3. NON MATERIAL AMENDMENTS

3.3 Basement Layout

FIG 2 _ PROPOSED _ Third floor plan

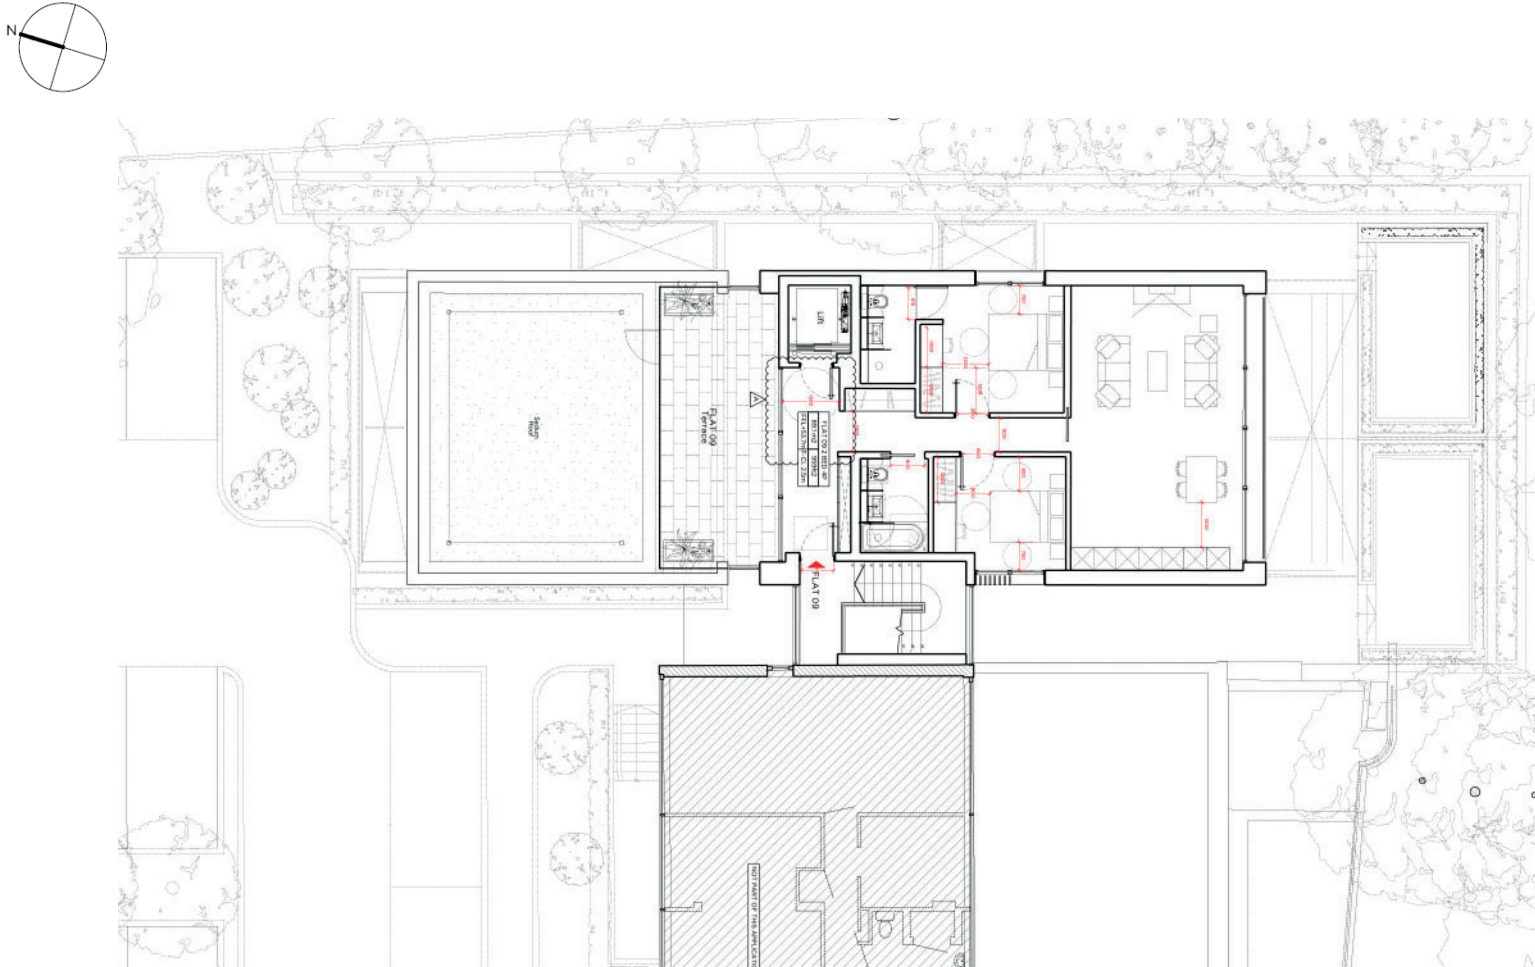
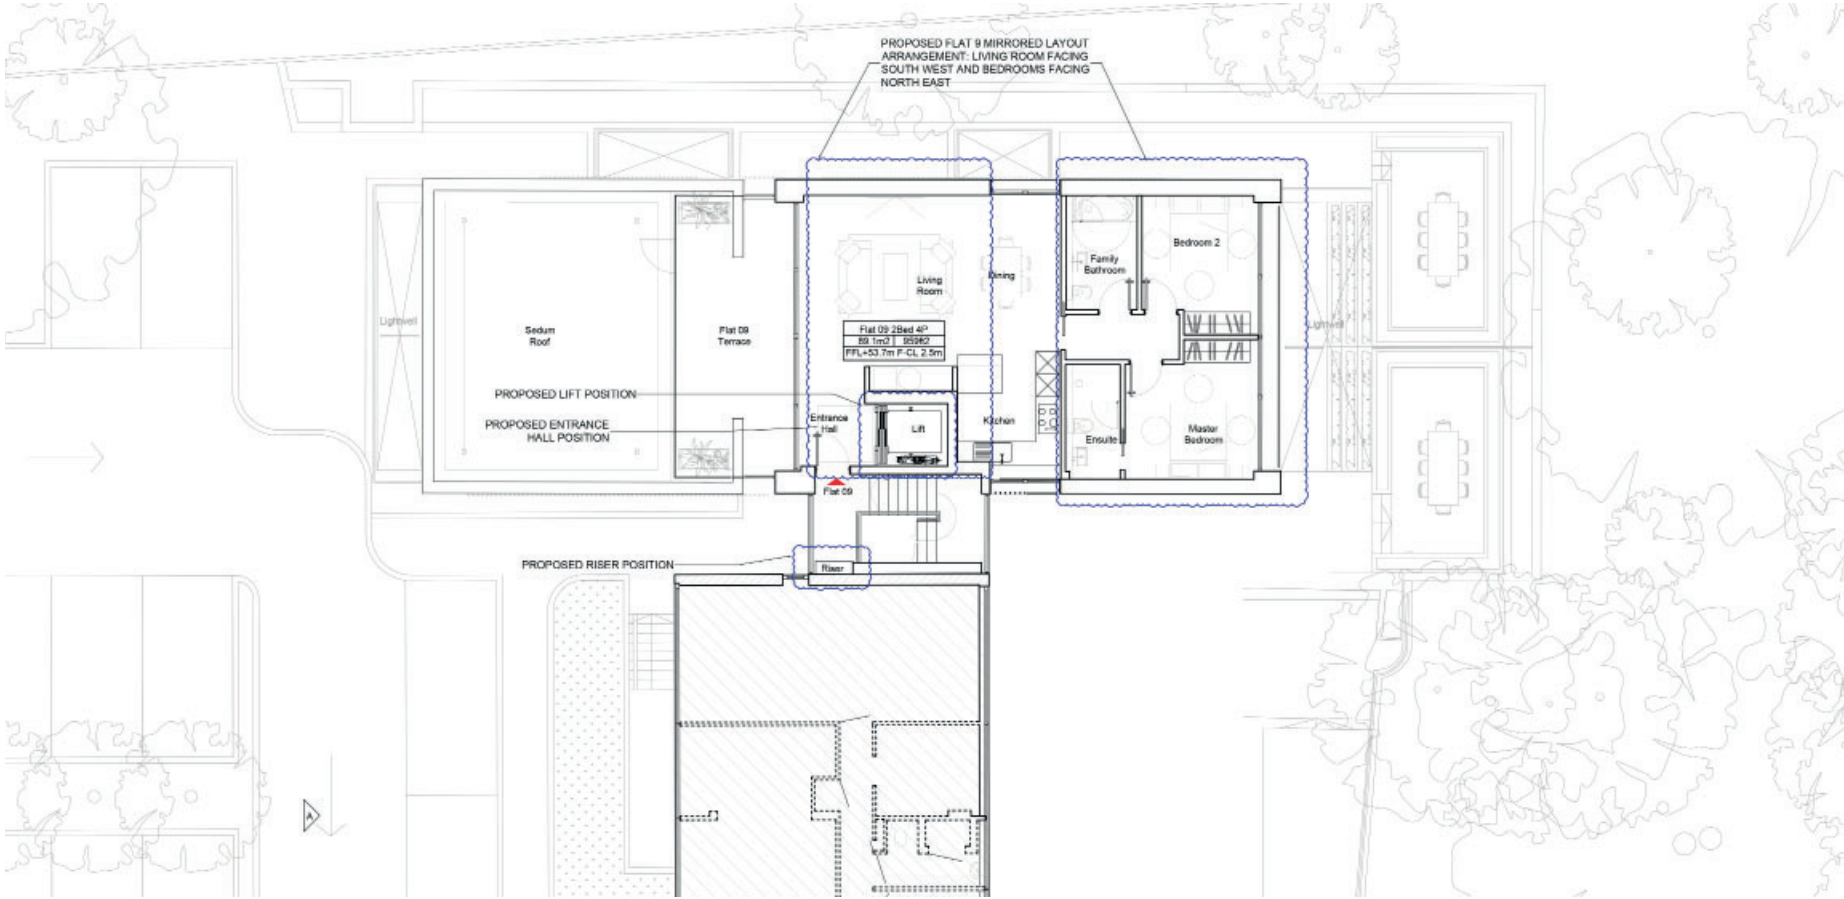
At the third-floor level, the change to the lift position resulted in the opportunity to maximise living area within the unit with a reduced corridor area. The floor plan allows for the living room to face south-west and with direct access to the external terrace. The bedrooms are proposed to face northeast with a view to the rear garden.

FIG 2 _ PROPOSED _ Roof plan

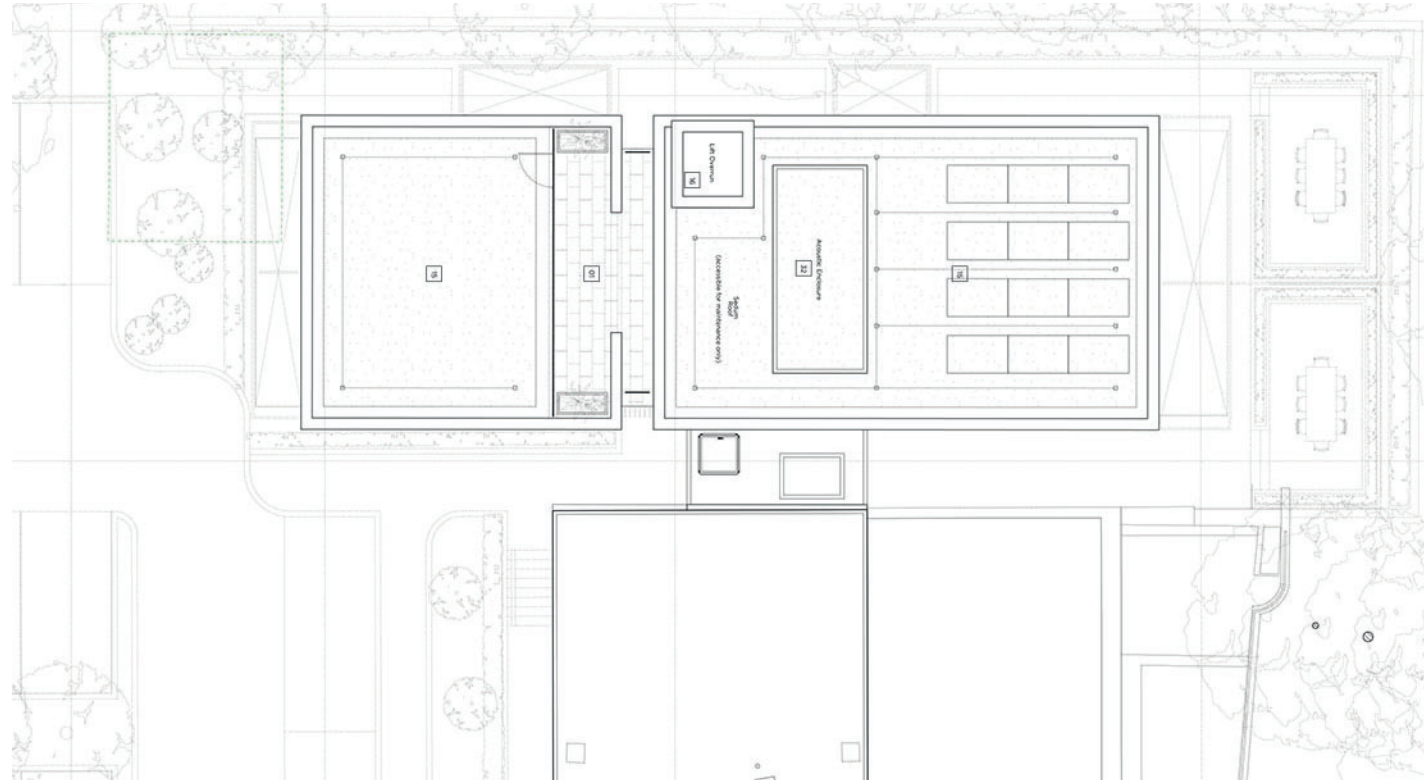
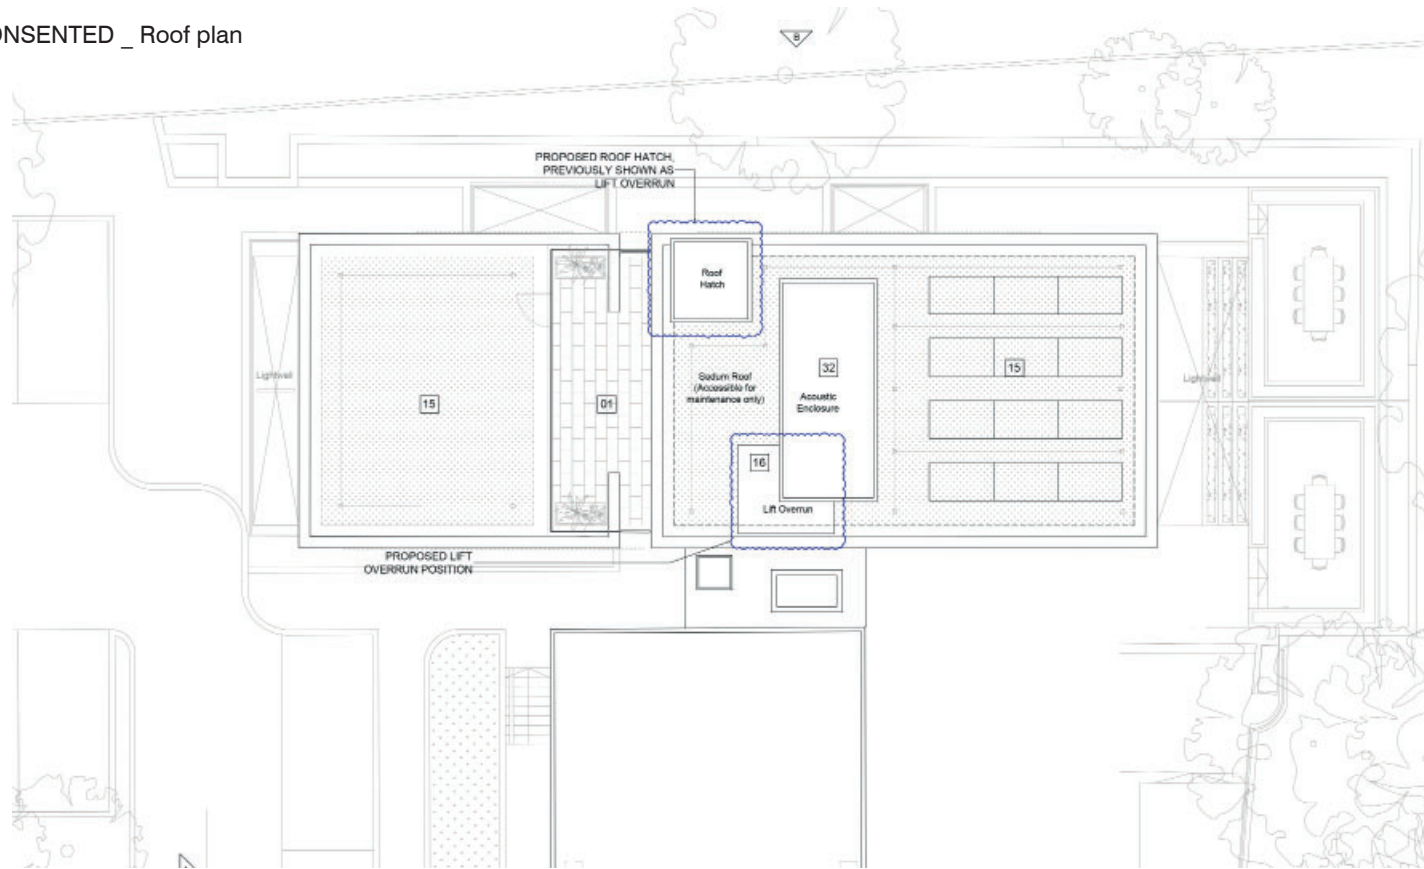
The only change at roof level is the relocation of the lift overrun. This was originally located to the north elevation therefore visible from public areas. In the new proposal this is now placed closer to Barrie House therefore concealed from public view (see 3.2).
